Subject: Revising the Central Urban Service Area boundary in the Town of Cross Plains

Resolution CARPC No. 2016-04

Amending the *Dane County Water Quality Plan* and the *Dane County Land Use and Transportation Plan* by Revising the Cross Plains Urban Service Area Boundaries in the Town of Cross Plains

Map 1 Amendment Area

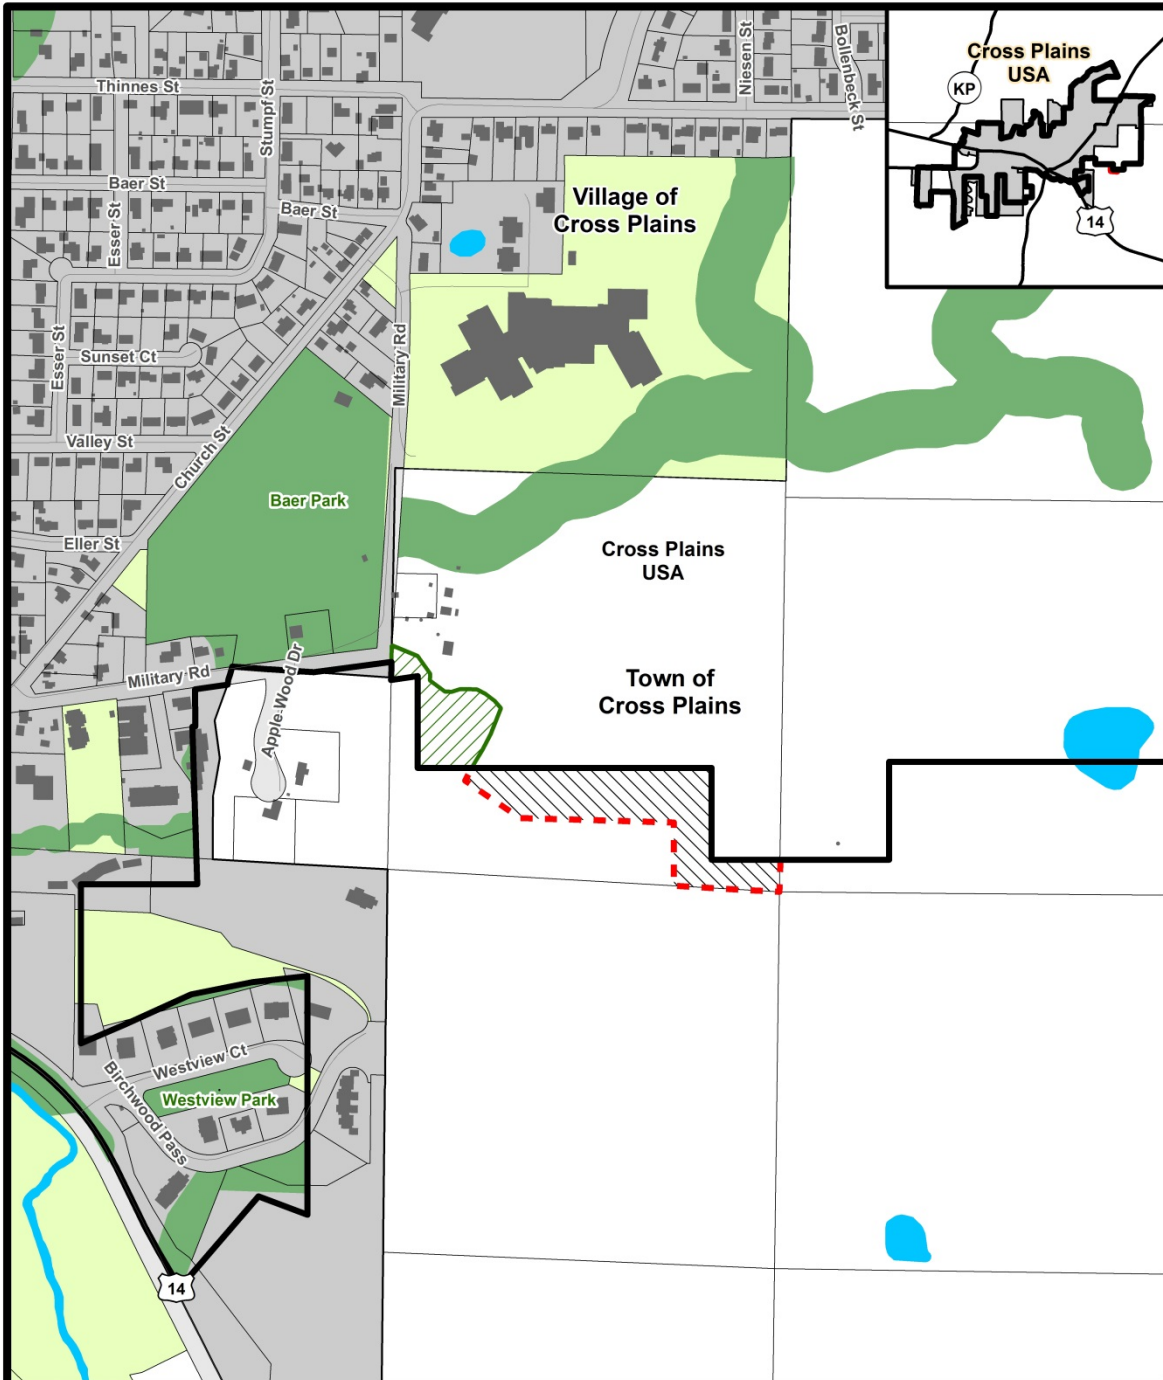
NOW, THEREFORE, BE IT RESOLVED that in accordance with Wis. Stats. § 66.0309, and Sec. 208 of Public Law 92-500, the Capital Area Regional Planning Commission amends the *Dane County Land Use and Transportation Plan* and recommends the amendment of the *Dane County Water Quality Plan* by revising the Cross Plains Urban Service Area and environmental corridors boundaries as shown on the attached map.

1. Submit a detailed stormwater management plan for CARPC and DCL&WCD staff review and approval prior to any land disturbing activities in the amendment area. The stormwater management plan should shall include the following:

2. All stormwater management facilities ~~should~~ shall be designated as environmental corridors, and preferably located in public outlots. Stormwater easements ~~should~~ shall be provided for any stormwater management facilities located on private property.

3. A preliminary site investigation for location of karst formations be done prior to design placement of stormwater infiltration facilities as required by the State of Wisconsin Technical Standard 1002 - Site Evaluation for Stormwater Infiltration.
